Memorandum

To: Planning Commission
From: Niall Connolly
Date: May 29th, 2026
Re: Parking Lot Extension, 50 Zion Park Blvd

SITE PLAN
FOR
SPRINGDALE PARKING LOT
SPRINGDALE
UTAH

Figure 1. Aerial view of parking lot, with the new spaces highlighted in red

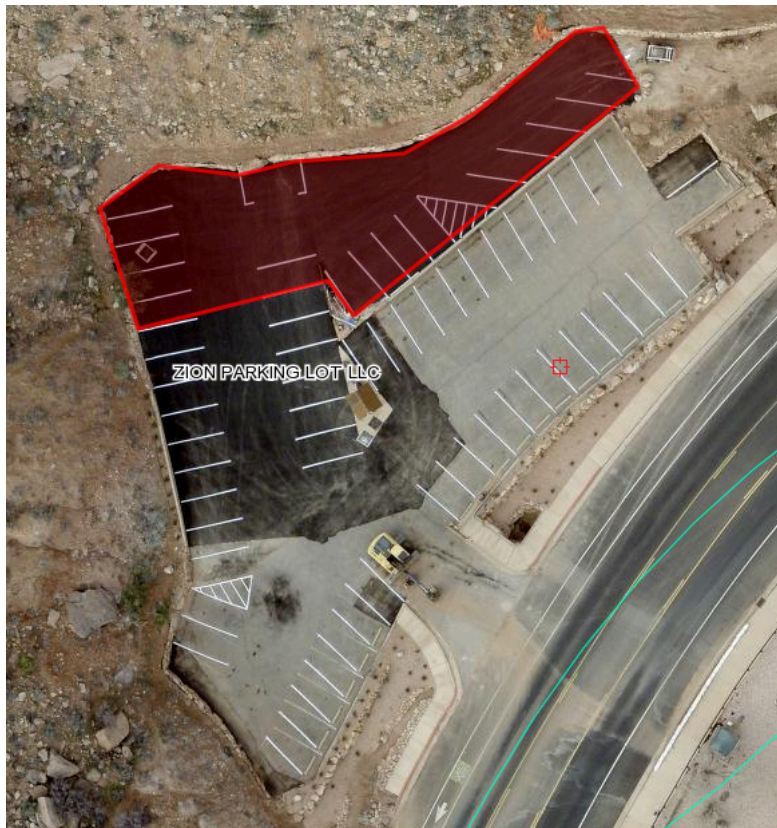
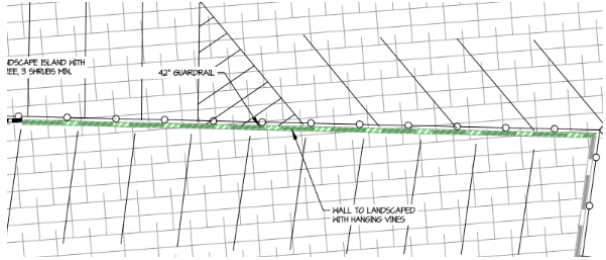
Mr. Luke Wilson has applied for design development review approval for expansion of his parking lot at 50 Zion Park Blvd. This expansion has already taken place, without approval from the Town. The expansion involved about 55 cubic yards of grading and 15 new parking spaces. The Town staff has required that the additional parking spaces be cordoned off and unused until approval has been given. The unauthorized parking expansion took place towards the end of 2025. Since then, Mr. Wilson has applied for, and been approved a grading permit retrospectively for the grading which took place. He is now applying for DDR approval.

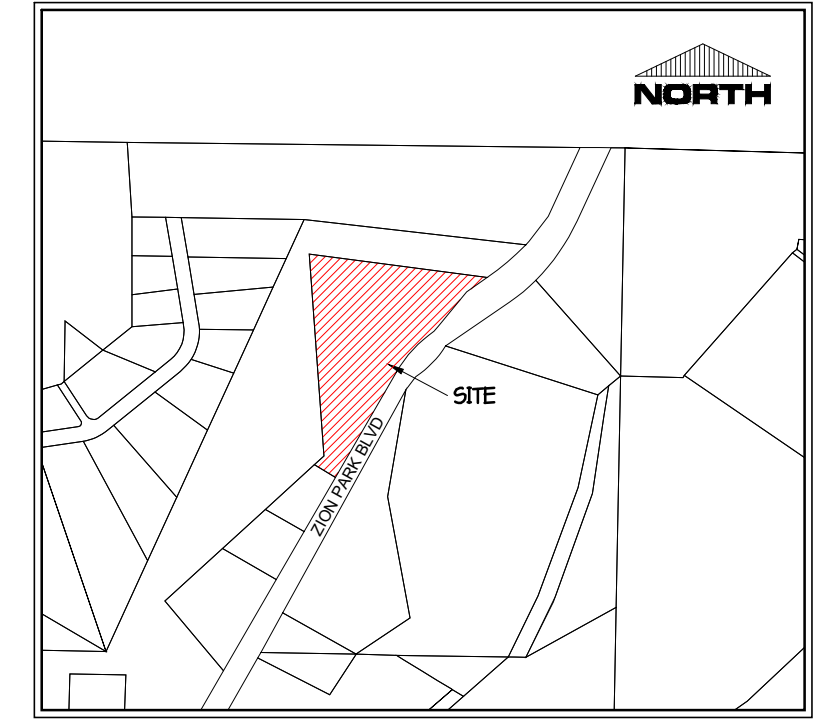
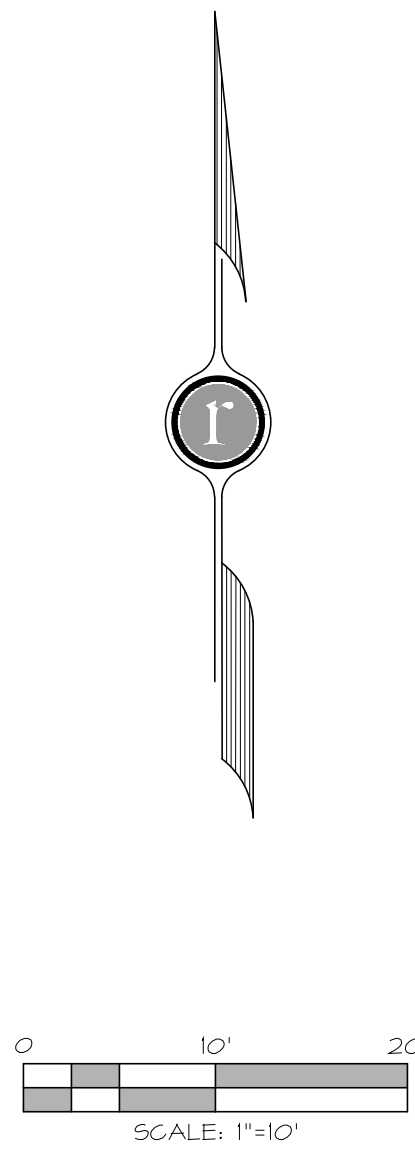
<p>Section 10-23-10:</p> <p>Off-street public parking areas must meet the following standards:</p> <p>A. <i>Restrooms:</i> Public parking areas must include restroom facilities that are open to people parking in the parking facility. The restrooms must be open and accessible at all times the public parking area is open and operating. Maintenance, utility charges, and other responsibilities and expenses associated with the restrooms are the responsibility of the parking area owner.</p> <p>B. <i>Trash and recycling:</i> The owner of a</p>	<p>A. There is no sewer connection at this property, and the public sewer is some distance away. Creating a connection would be extremely costly. The applicant has instead proposed a “self-contained rest room facility with metal screens”. This is essentially a “porta-potty”, but would be screened by metal panels. The applicant would be responsible for routinely emptying these. The Planning Commission may wish to impose a condition on the screening of this facility.</p> <p>B. The plan does not show trash and</p>

recycling receptacles. The Planning Commission may wish to impose a condition requiring trash and recycling receptacles.

The expanded area of asphalt has the potential to increase surface water runoff flows. Generally, the next step after DDR approval is for the applicant to submit engineered plans which would address this issue. In the case of a parking lot, where a building permit is not required, the Town has previously required these plans as part of a grading permit. In this case, the applicant already has a grading permit. The Commission may therefore wish to require this by a planning condition.

1. A surface water drainage strategy and plan must be submitted for approval to the Town of Springdale within two months of the date of this approval. The applicant shall work with the Town Engineer to ensure that the additional surface water generated by this expansion is managed in accordance with the Town’s relevant standards.
2. The restrooms shall be screened with a material(s) that complies with the Town’s architectural design standards. The applicant shall provide details of this to the Community Development Department for approval.
3. The applicant shall provide trash and recycling receptacles on the property.
